Subject: AP1000 Response to Request for Additional Information (SRP 6)

RAI Response Number: RAI-SRP6.2.2-SRSB-11
Revision: 2

Provide responses to the following questions related to APP-PXS-GLR-001, Revision 0, "Impact on AP1000 Post-LCOA Long Term Cooling of Postulated Containment Sump Debris," issued April 28, 2008:

Figure RAI-SRP 6.2.2-SRSB-11c-1: DCD Chapter 15.6.5.4C Analysis Integrated Core Boiloff Rate, IRWST Injection Phase

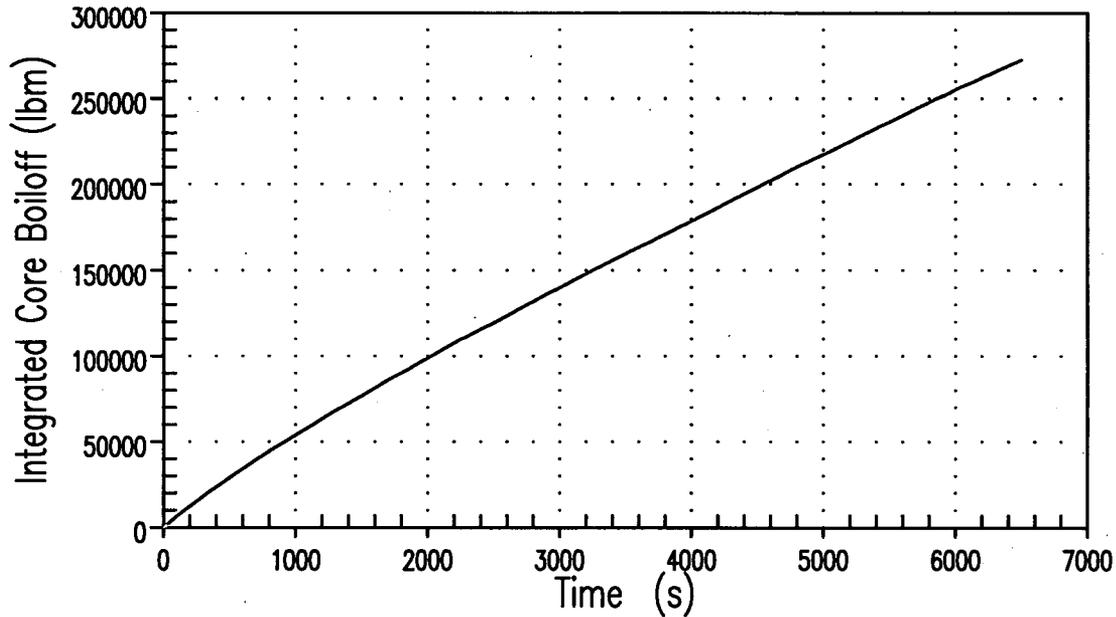
- c. Provide plots of the integrated core boiloff rate and integrated core inlet flow rate for each of the cases analyzed, including the two sensitivity cases.

- c. The plots of integrated core boiloff rate and integrated core inlet flow rate are provided for the DCD long-term cooling analysis presented in Chapter 15.6.5.4C for both the IRWST injection and the containment recirculation segments of the DEDVI break transient, and for the three core entrance resistance sensitivity cases for an equivalent length of time during the containment recirculation phase.

Containment recirculation phase sensitivity cases 1 and 2 are window mode computations that begin at 6500 seconds WCOBRA/TRAC problem time; Sensitivity Case 3 begins at 7200 seconds WCOBRA/TRAC problem time. Each case ultimately reflects the quasi-steady-state containment floodup level. The core inlet flow rate integrals show less liquid enters the core in Sensitivity Case 1 than in the DCD analysis, that less liquid enters the core in Sensitivity Case 2 (a higher resistance sensitivity case) than Sensitivity Case 1, and that less liquid enters the core in Sensitivity Case 3 (the highest resistance sensitivity case) than Sensitivity Case 2. Thus, lower core inlet flow results from the reduced DVI flow rates that are predicted for containment recirculation as a consequence of the postulated sump screen and core inlet blockages.

Figure RAI-SRP 6.2.2-SRSB-11c-7: Containment Recirculation Sensitivity Case 2 Integrated Core Boiloff Rate, Containment Recirculation Phase

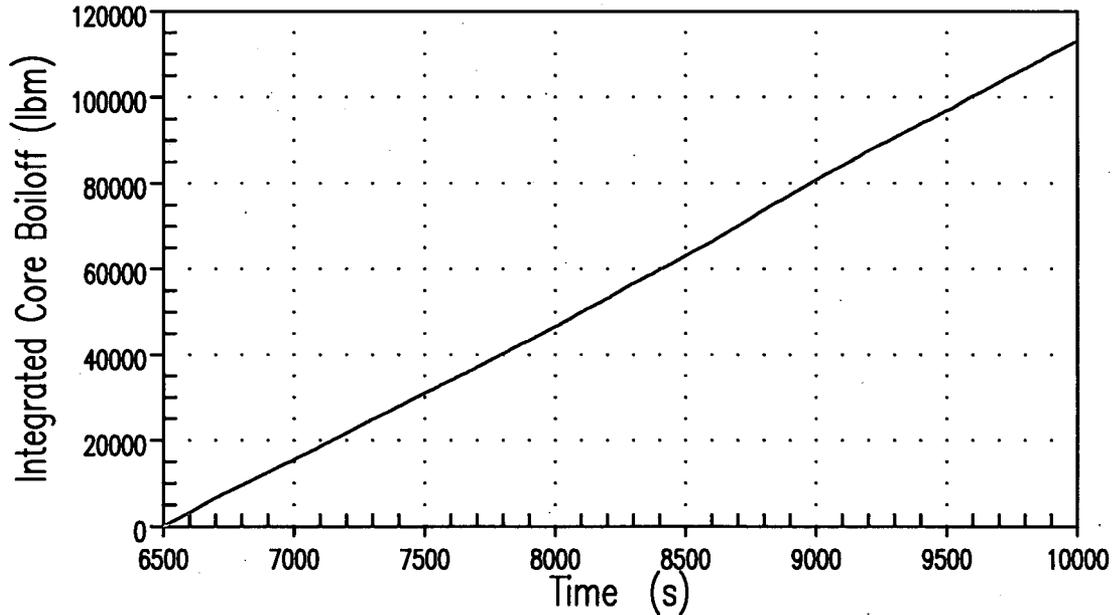
- a. The RAI requested the debris and chemical loading for water bypassing the sump screen and Westinghouse's response refers to TR 26, Revision 3, Table 5 for the latent debris. Table 5 does not provide the answer for a.
- b. When does the reverse flow into the DVI break line occur? What is the time dependent water level in the containment? How is % bypass factor determined from these flows? What is the % bypass during the transient, not the average integrated bypass, but the time dependent % bypass.
- c. Why are the integrated core boiloff for the sensitivity cases (Figures RAI-SRP 6.2.2 – SRSC-11c-5 and -7) lower than that of the DCD base case (Figure RAI-SRP 6.2.2 – SRSC-11c-2) having the same decay heat?

- c. All of the referenced cases are performed using the 1971 ANS Infinite +20% decay heat function, according to 10CFR50 Appendix K. The difference in core boiloff observed is a consequence of the lower plenum liquid enthalpy being calculated.
